TVA-BFN-TS-403

**BROWNS FERRY NUCLEAR PLANT (BFN) - UNITS 1, 2, AND 3 -  
TECHNICAL SPECIFICATIONS (TS) CHANGE 403 - INCORPORATION OF  
GENERIC TS CHANGES - TS SECTIONS 1.4, 3.0, 3.1.4, AND 5.0 -  
TAC NOS. MA9423, MA9424, AND MA9425**

PROPOSED TECHNICAL SPECIFICATIONS (TS) CHANGE TS-403  
INCORPORATION OF GENERIC TS CHANGES  
TS SECTIONS 1.4, 3.0, 3.1.4, AND 5.0

**Add Example of SFDP to the 3.0.6 Bases**

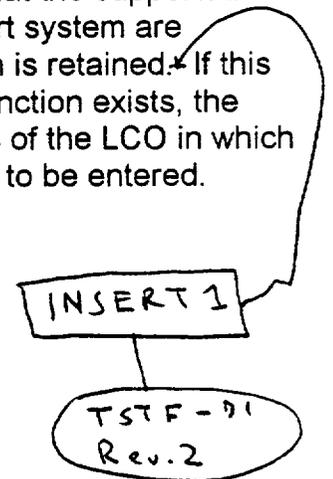
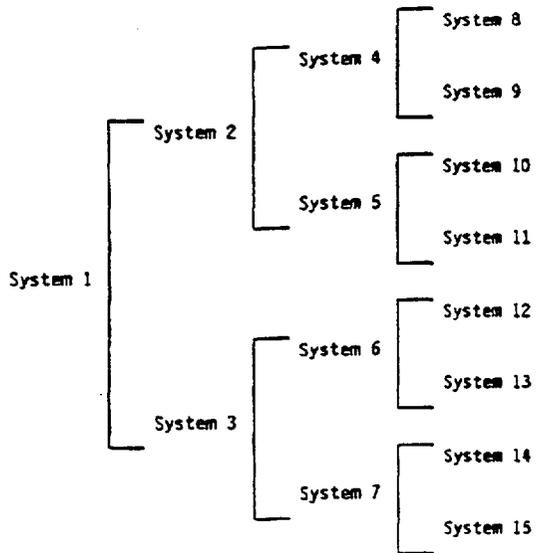
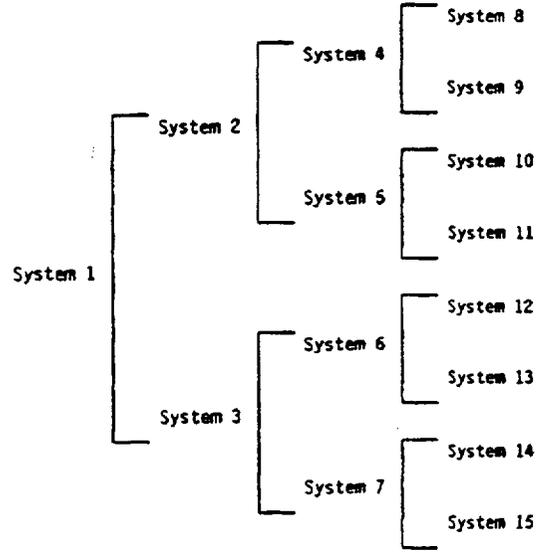
TSTF-71, Revision 2, adds an example of the application of the SFDP to the Bases for LCO 3.0.6 for illustration purposes. This change does not affect the application of LCO 3.0.6, therefore, the change is considered an administrative change which serves to improve TS usefulness by providing an example.

All changes  
TSTF-258 Rev. 4

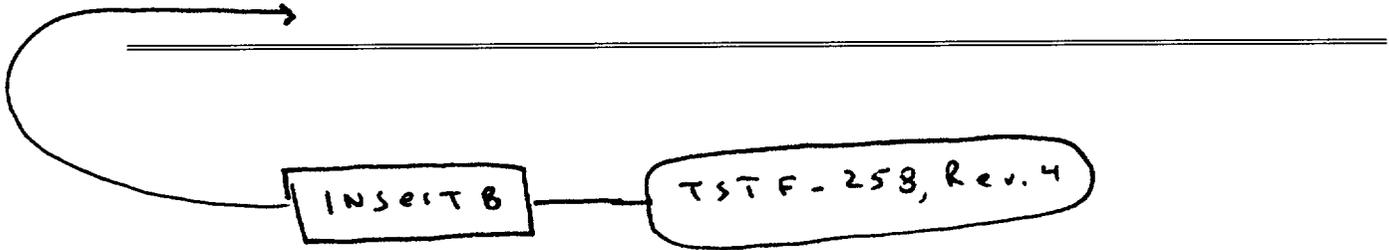
TS Section 5.2.2.g is being revised to eliminate the position title of "Shift Technical Advisor (STA)."

- e. (1) The Operations Superintendent shall hold a current SRO license on a Browns Ferry unit. A - individual
- b. (2) ~~The Shift Technical Advisor (STA)~~ shall provide advisory technical support to the ~~Shift Manager~~ in the areas of thermal hydraulics, reactor engineering, and plant analysis with regard to the safe operation of the unit. ~~In addition, the STA~~ shall meet the qualifications specified by the Commission Policy Statement on Engineering Expertise on Shift.

Shift operating crew \*

\* BFN specific nomenclature
